Access Compliance Report

Public Rights-of-Way

Intersection ID: 5518	Main Street: MISTY_VALE_RD	Cross Street: NORTHWOODS_FOREST_DR	Location: NE
ADA ID: 01EC64D7E13E	Ramp Type: BlendTrans1	Initial Pass/Fail: Fail	Overall Compliance: No
		Severity Score: 1.25

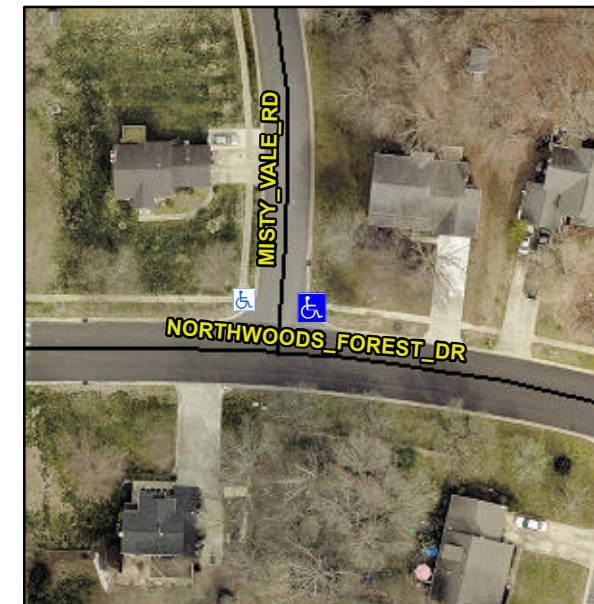
Not Found, R304.5.3

N/A	Ramp inside XWalk1?	N/A	N/A	Ramp inside XWalk2?	N/A
	Road Slope (%)	4.5		Clear Space?	N/A
	Road X Slope (%)	1.0	N/A	Clear Space to XWalk (in)	N/A
N/A	Any Obstructions?	N/A	N/A	Storm Grate/Utility Hazard?	N/A
	Obstruction Type			Storm Grate/Utility Type	
		N/A			N/A
			Yes	Surface Condition? (G/P)	Good
			No	Curb Slope (%)	18.6

Remove & Replace Curb Ramp With Two New Directional Ramps or Equivalent.
